# Conceptual Review Agenda

Schedule for 10/17/16 to 10/17/16

# East Ridge Residential

# 3001 Elizabeth St. Triplex

**SITE PLAN** 1"=10'-0"

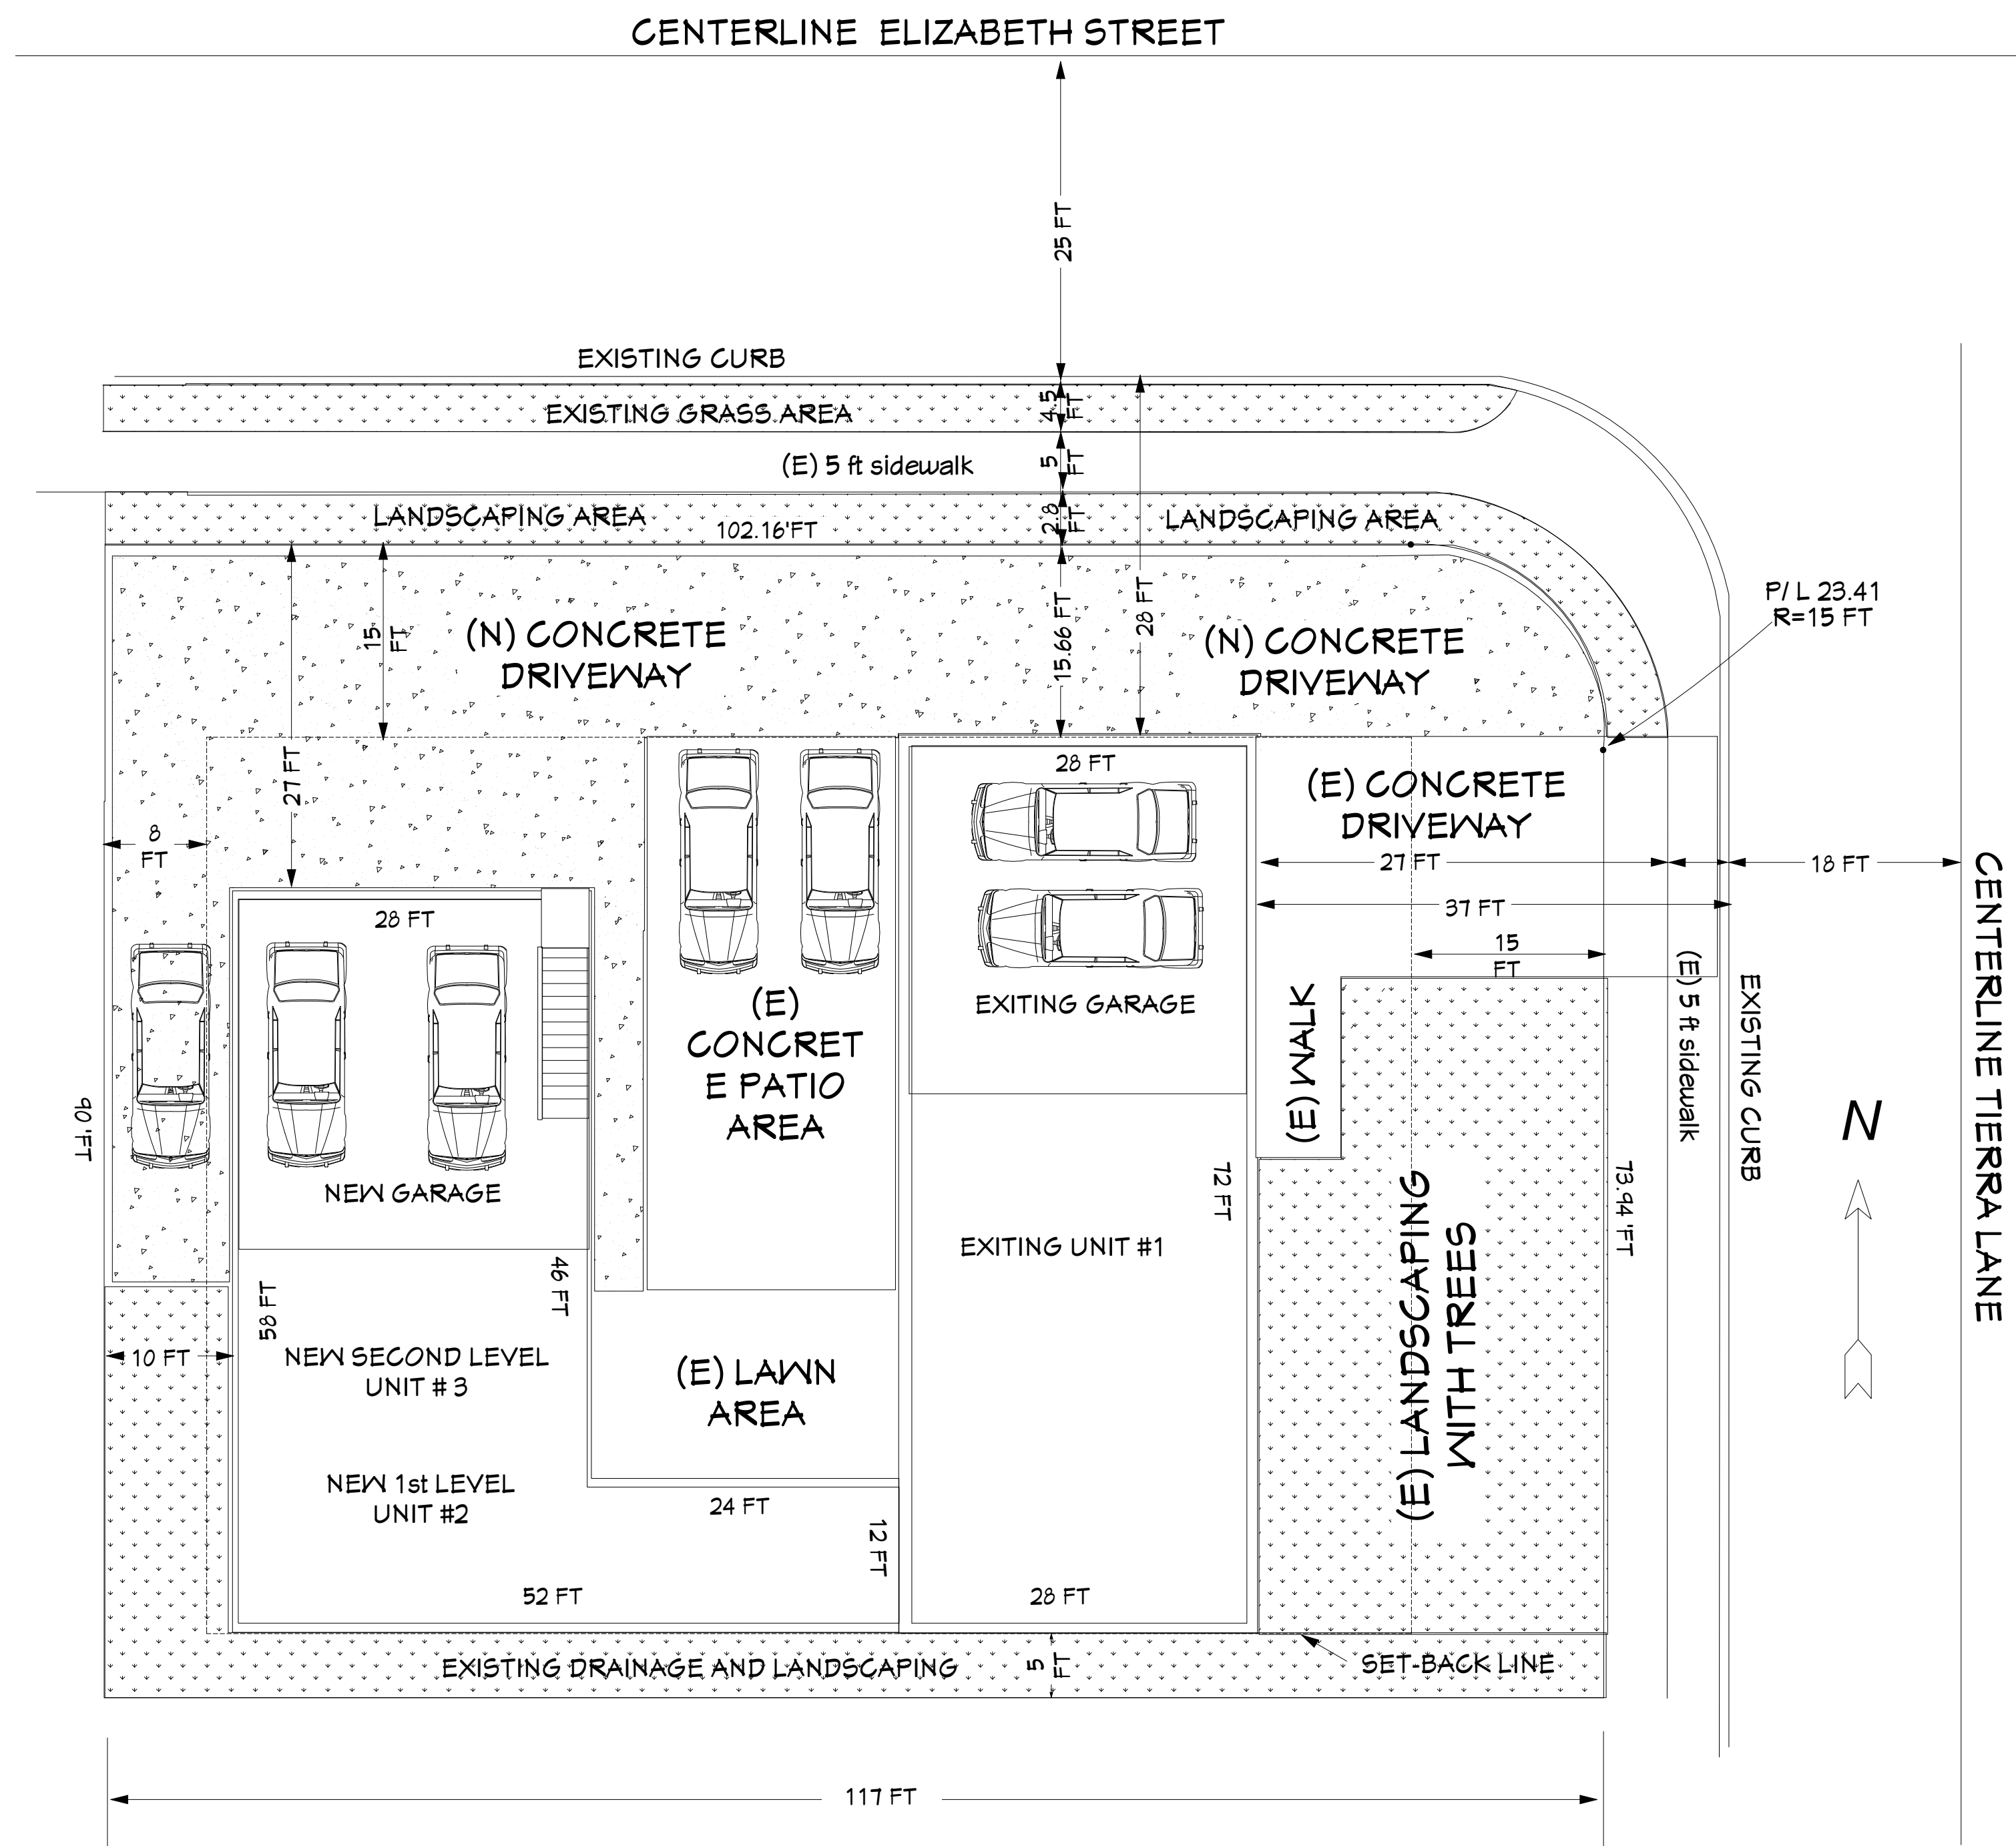
1. The anticipated change in traffic volume is not expected to rise to the threshold of needing a TIS. Based on section 4.2.3.D of LCUASS, the Traffic Impact Study requirement can be waived.
2. Please work with the Engineering department to determine the extent of improvements required along Elizabeth.
3. Access should be taken off of Tierra, as shown.

1. The proposed density is 12.6 dwelling units per acre. This exceeds the maximum density of the zone district by 3.6 dwelling units per acre. Staff does not and will not support a modification to this standard.

2. A landscape plan will be required as part of this project. You will need to demonstrate in particular how you are screening the driveway and parking from adjacent uses and properties.

4. How will trash and recycling be handled?
5. This development must be within 1,320 feet walking distance from a central gathering feature or park without crossing an arterial street. Please demonstrate how you meet this standard. If you do not meet this standard, you must either provide this amenity or seek a modification request.

6. Your property is adjacent to a single-family home across the street. Due to this adjacency, you must provide a 25' buffer yard in the front yard to provide buffering from this home. Your current plan does not meet this standard. Please provide a detailed landscape plan that shows how you will be providing buffering in the front yard.
